22nd November 2022  
(via email)

**With reference to Planning Application 21/2758/FUL, Landscape and Public Realm Strategy pt 1, pp33-34: Strategies Play**

The Twickenham Riverside Trust would like to add to its Objection of January 2022 (included at the foot of this document for your convenience).

Page 33:

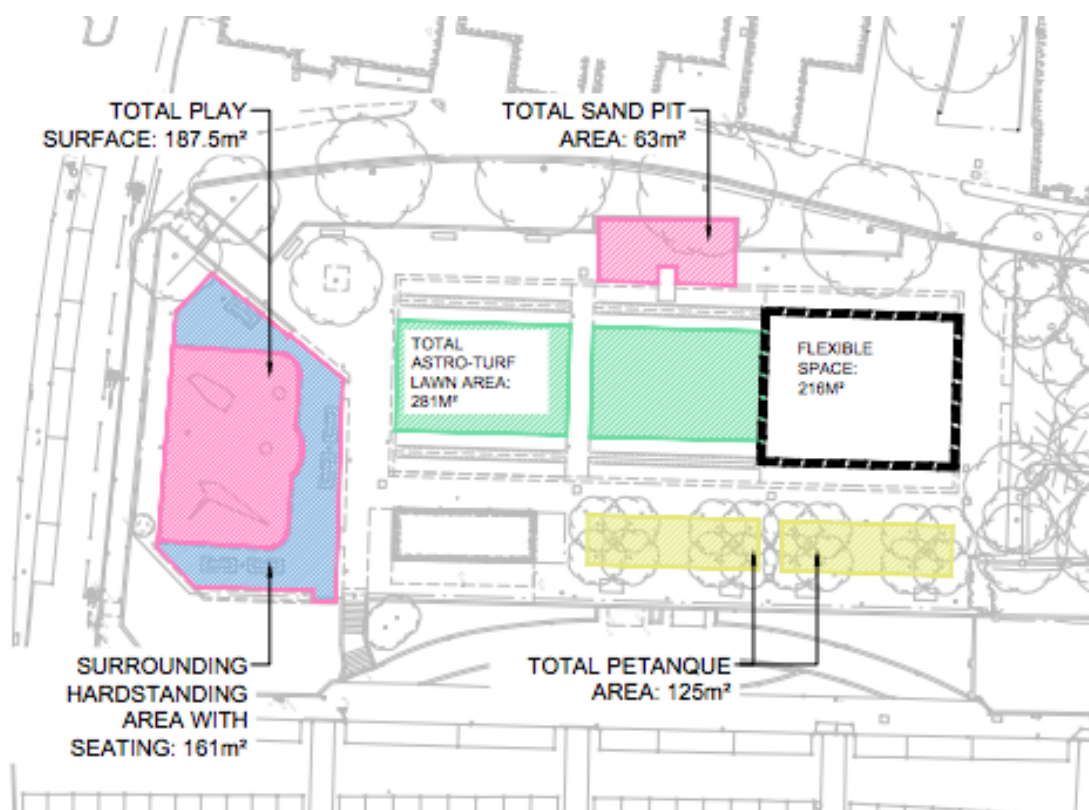
Existing playground: the above diagram describes 161m2 of the enclosed children's play area as "surrounding hardstanding area with seating", and does not include it in the total of

the existing play provision. This completely ignores its existing function as play space in the enclosed playground, as outlined in the Trust's Observation of January 2022 (reproduced below). Play space is not defined by surface material, but rather by function. This "hardstanding area" functions as play area within the enclosed playground.

The existing playspace provision within the enclosed playground (using the Applicant's measurements) is therefore  $187.5\text{m}^2 + 161\text{m}^2 = 348.5\text{m}^2$ . For the purposes of comparison with the proposed playground, an area of  $10\text{m}^2$  (a generous allowance for the footprint of the five benches in the existing enclosed playground) is subtracted from the existing play area to give a net area of  $338.5\text{m}^2$ .

Combined with the existing sandpit area of  $63\text{m}^2$ , this gives a combined existing 'formal' play area of  $401.5\text{m}^2$ .

The proposed play area has a GLA uplift requirement (to accommodate residents of the proposed residential development) of  $148.6\text{m}^2$ .

Accordingly, the proposed development is required to provide  $401.5 + 148.6 = 550.1\text{m}^2$ .

Page 34:

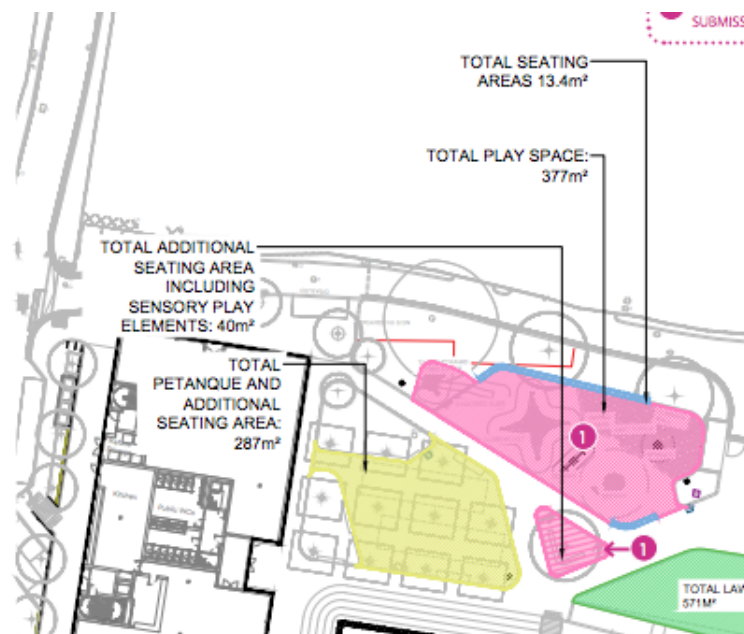
The proposed play area totals  $377 + 40 = 417\text{m}^2$ .

**This proposed area falls short of the required play area by  $133.1\text{m}^2$  ( existing  $550.1\text{m}^2$  - proposed  $418\text{m}^2$ ), or 24%.**

The above is an assessment based on m2 only. It does not include the considerable and immeasurable benefit to children of being able to play freely and safely within an enclosed area.

“Event Space” (October 2022 drawing):

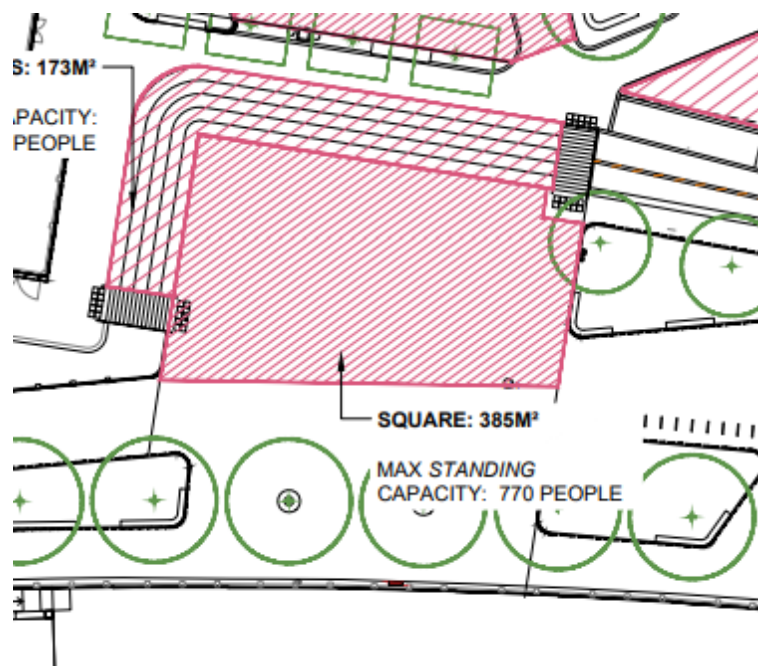
The revised October 2022 drawing “Event Space” now shows an ‘Event Space’ or “Square’. This is being proposed as equivalent to the existing hard standing (labelled ‘flexible space’) in the Diamond Jubilee Gardens. However, it lacks, the Trust would argue, the amenity value/extendable usage of being contiguous with other play spaces.

It is also, most significantly, adjacent to a main pedestrian/cycle route, with a secondary pedestrian route running through it:

**Figure 4-4 - Cycle movement and access concept through the site (source: Hopkins)**

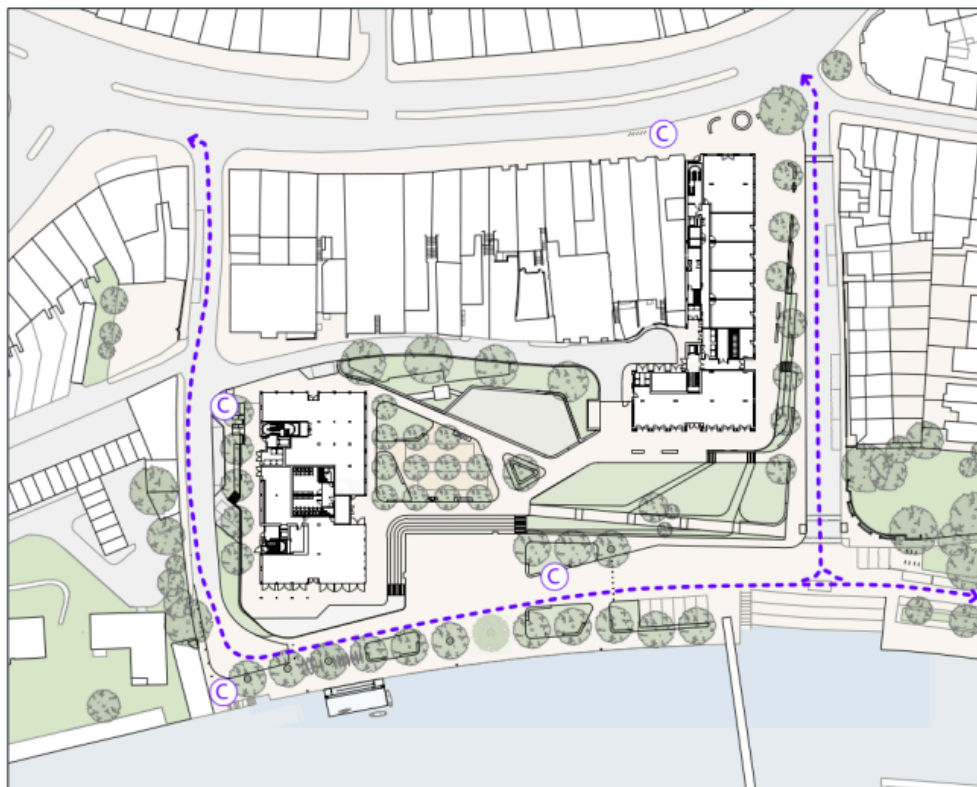
This proposed 'Event Area'/'Square' is clearly also suitable for scootering and roller blading/skating, though not ball games as it adjacent to the river. However, children enjoying free play in this area will not have had sight of the October 2022 drawing, which delineates the proposed area of activity. The potential for conflict with cyclists - this latter also having the 'designed-in' potential for conflict with pedestrians - is clear.

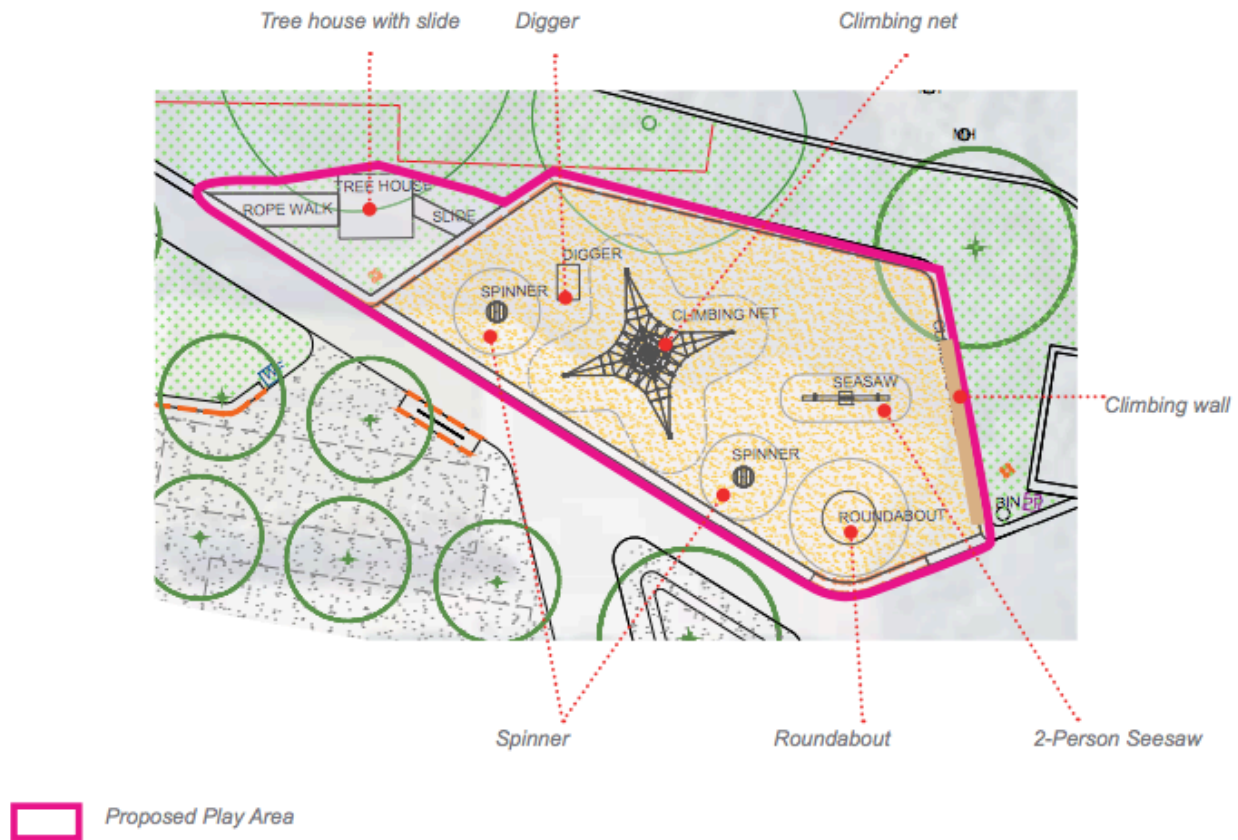
The enclosed playground in the present Gardens measures 430m<sup>2</sup>. This consists of c. 350m<sup>2</sup> of play area, with a formerly planted border of c.80m<sup>2</sup>:

However, the Landscape and Public Realm Strategy in the Council's development proposal measures only the spongy area within the existing playground/play area:

Using this 'definition' of the playground/play area, according to the Landscape and Public Realm Strategy, the existing playground covers an area of just 187m<sup>2</sup>. However, this measurement does not take into account any of the seating areas or the safe runaround/incidental play area within the enclosed playground.
